PROJECT: SANTRY AVENUE STRATEGIC HOUSING DEVELOPMENT

**REPORT: STATEMENT OF RESPONSE TO AN BORD PLEANÁLA'S NOTICE
OF PRE-APPLICATION CONSULTATION OPINION: REF: ABP-
308093-20**

CLIENT: DWYER NOLAN DEVELOPMENTS LTD.

DATE: 16|07|21

Fig. 4 – land hatched in red is in the control of Dublin City Council who has consented to their inclusion in this SHD planning application – the blue on the image above refers to the lands in the control of the applicant, to illustrate the difference in land ownership.

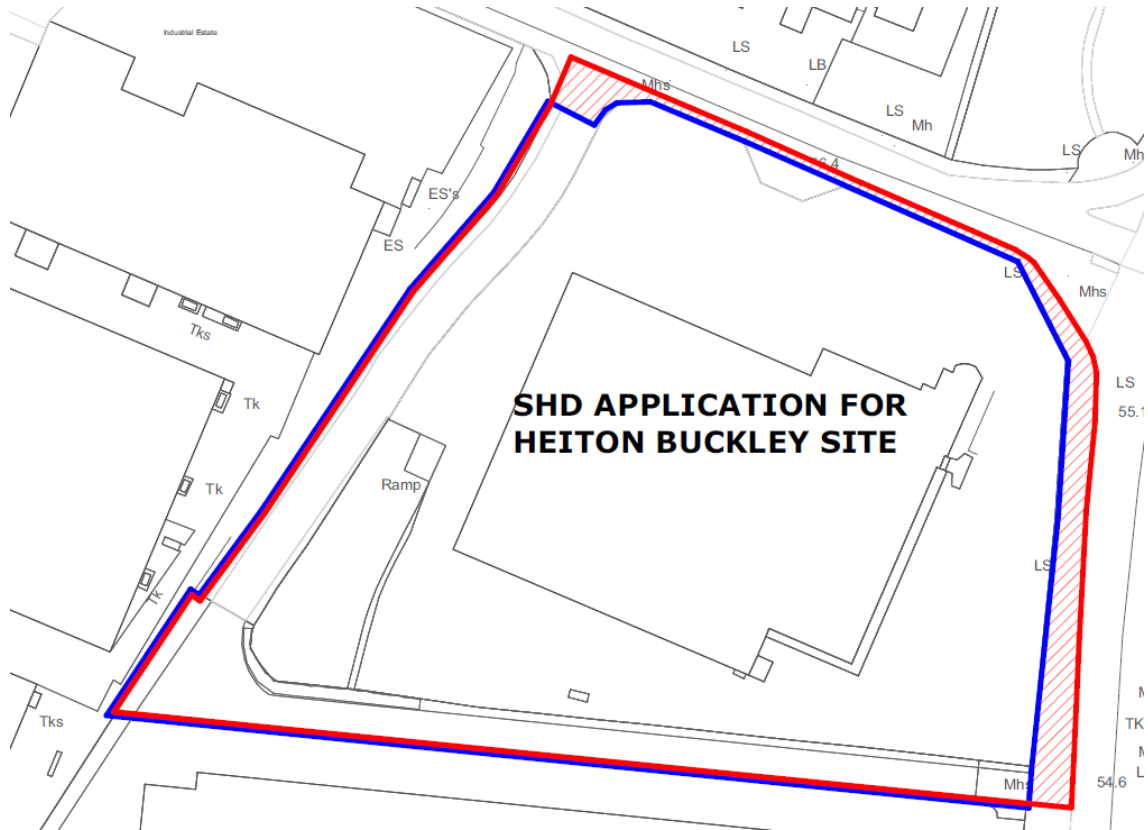
Item 2 - *Drawings and detailed specifications that show works on and in the public realm, specifically upgrades to junctions and footpaths. In addition, drawings should show, if known, the alignment and requirements for any future public transport improvements along the Swords Road (BusConnects). This may require further engagement with the local authority and any other agencies responsible for delivery of same. The applicant shall clarify how the works in the public realm will be carried out and by whom.*

Dublin City Council has provided a letter of consent to the applicant, consenting to the inclusion of their lands, specifically within the footpaths and roadway, which is hatched in red, on the extract from the relevant map attached to the enclosed letter of consent, dated 14th June 2021. It is the applicant’s intention to carry out all of the works proposed within the red line of application, including works on and in the public realm, and upgrades to junctions and footpaths, subject to agreement with Dublin City Council, once an order to grant permission is issued.
